9505A Product Launch Q & A

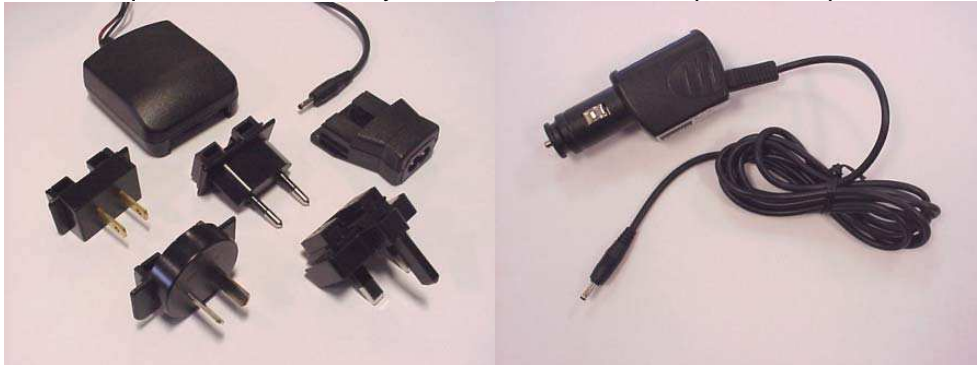
- Iridium replaced the IR Port with a 7mm power jack. The accessory connector on the bottom of the phone is no longer used for charging the phone.

- Iridium modified the accessory connector on the bottom of the phone to prevent 9505 accessories from being used on the 9505A and visa versa.
